REDEVELOPMENT OF HARBOURSIDE SHOPPING CENTRE

SSD16_7874

Public Submission

Nick & Caterina Chiefari
Owners of
302/50 Murray Street Pyrmont
known as One Darling Harbour
cathy@elbakitchens.com

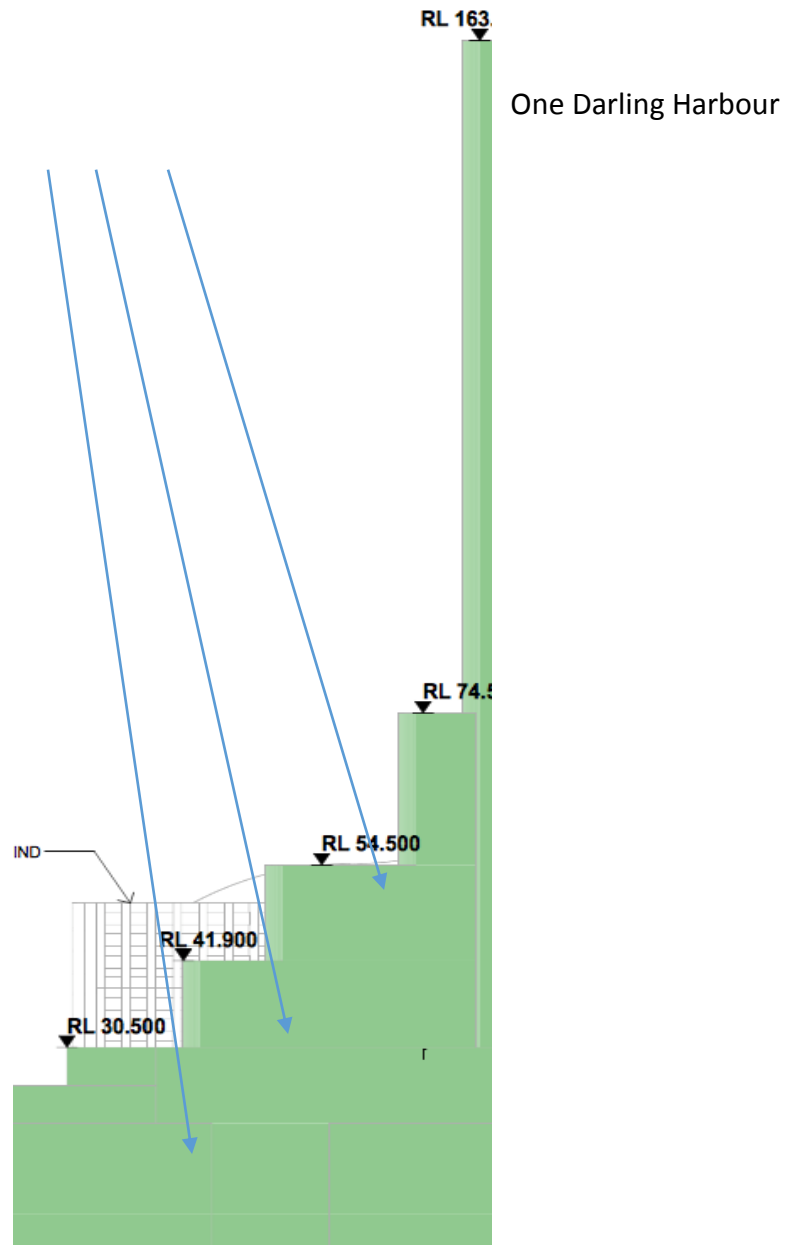
The Sydney CBD is located immediately to the east of the site and comprises a wide variety of buildings of varied heights, scales and designs. CBD buildings generally reduce in scale the closer they are to Darling Harbour. The transitional approach to building scale is reinforced in the immediate context of the 'dress circle' by the Darling Park Towers, which step down from RL140 to RL 98 with RL for IMAX at 93.5, with RL 130.0 for the element of the ICC Hotel. The 'inner circle' is characterized by the new ICC centre in Cockle Bay with an RL50

The proposal's is for a non-residential platform of varying RLs from 30.5 to 17.5. On top of this platform it is proposed to put several floor plates of residential at RL41.9, RL 54.5 and 74.5, before a further tower element to RL 166. In fact the proponent has a tower on a very large platform which a tower sits on; the tower is set back at RL30.5, again set back at RL41.9, again set back at RL54.5 and again set back at RL 74.5. To put this in context, the height at which the tower is set back at RL74.5 is well over the height of One Darling Harbour.

The bulk and scale of the tower in particular contrasts with the lower scale character of the Darling Harbour precinct and therefore is visually quite dominant and compromises and unsympathetic to the established valley floor character. The massive floor plates are totally unacceptable. The proponent states the floor plates are soem1,000sqm but this is at the top of the tower. They are massive floor plates lower down as the set backs take effect. This is a residential development and not a commercial commercial as before where floor plates of up to 1,200sqm are acceptable. The Department often quotes that residential towers should not exceed a floor plate of 600-800GBA and this should certainly be the limit in this sensitive area of Sydney.

I consider for these reasonsThe ‘wings’ of the tower element are not acceptable and should not be supported and the Tower floor plate above the shopping centre platform not exceed 800GBA with a maximum width of 25 meters.

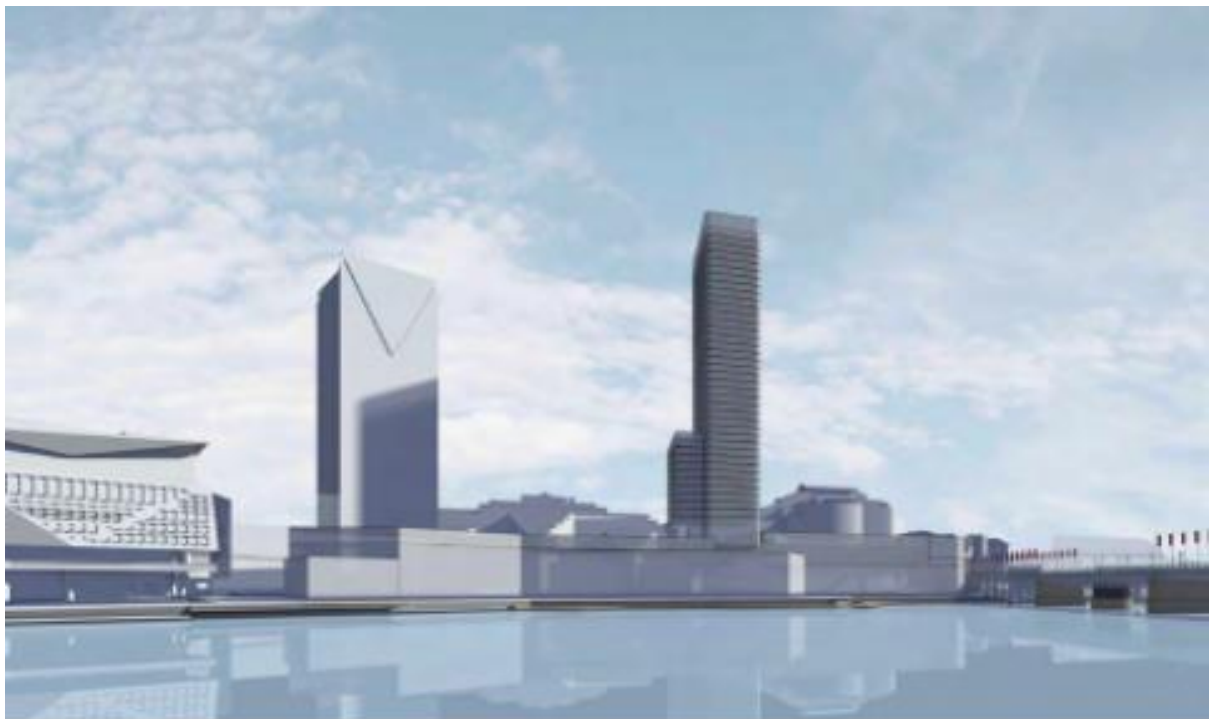
The height of southern section of the proposal is at RL 25. At the northern edge the RL climbs to RL 166 and declines with platforms at RL30.5 and RL23.8 some 10 meters from the heritage bridge.

The proposed massing across the site to the north is inconsistent with the proximity of the Heritage listed Pymont Bridge. The IMAX (RL50) defines the termination to the south of Cockle Bay and Pymont Bridge defines the termination of Cockle Bay to the north and the massing of the proposal towards the Bridge is inappropriate, unsympathetic and overpowering. Particularly when the proponent offers the Central Tower option which will have far less impact on the heritage bridge allow the immediate setting of the bridge to be retained.
